CHANGES FROM BASE PRODUCT VBV-14025 (1554) TO AC-070 (5430)

Angle of Projection Third Angle	Assembly PI Approval J GREEN	Approved by D WALLIN	Checked by IDEASY	Drawn by W.SINDEN
	Units mm	Scale N/A	Released 22/08/18	Assembly Ref -
Status RELEASED	AC-070			
Part No 5430	BE-003788-00-18

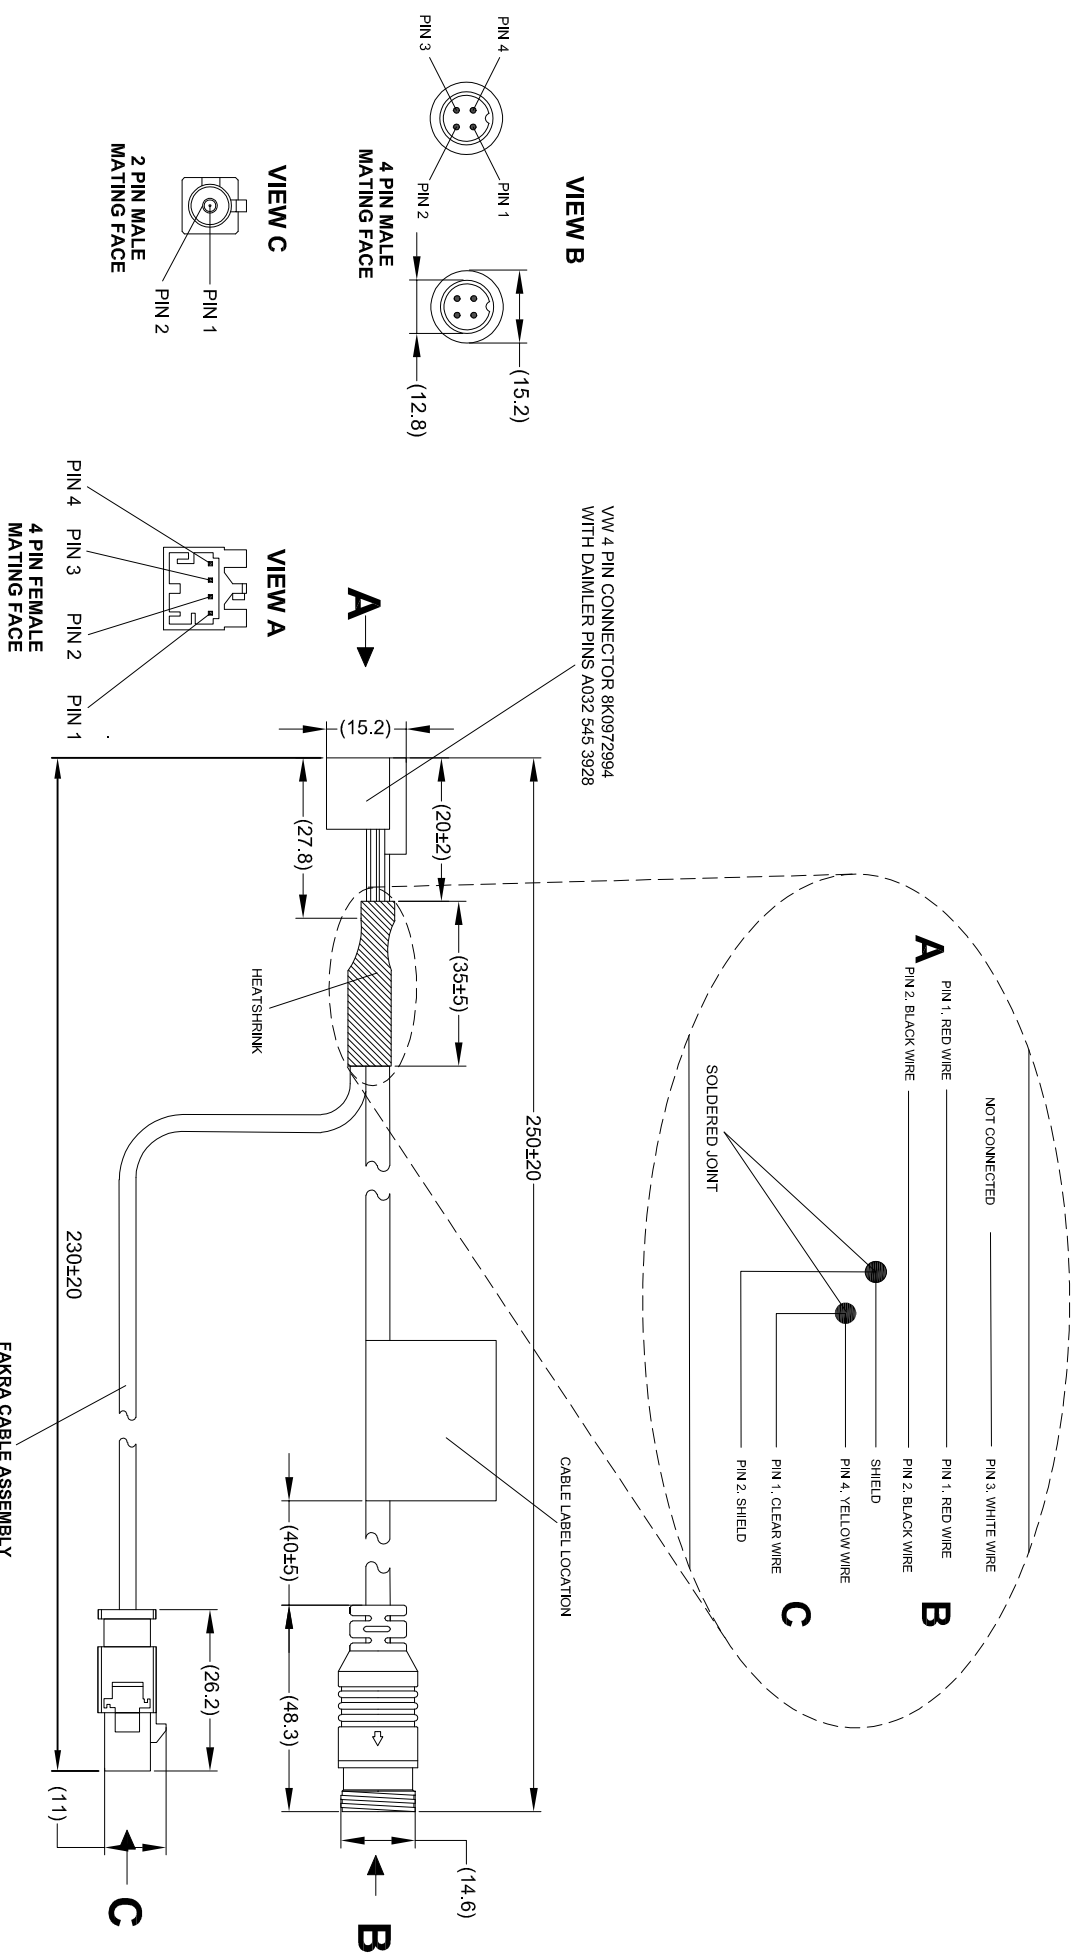
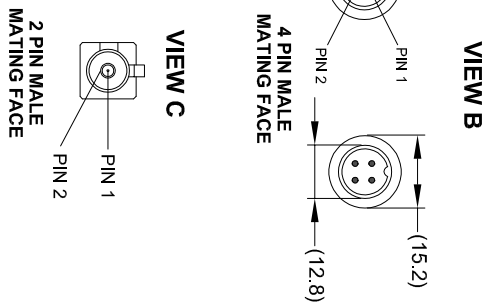
- CHANGE:
1. REPLACE 4 PIN FEMALE VBV CONNECTOR WITH FAKRA CABLE AND VW 4 PIN CONNECTOR
 2. VBV-14025 GB-LBL TO BE REPLACED BY AC-070 (5430) GB-LBL
 3. VBV-14025 GB-LBL REPLACED BY AC-070 GB-LBL
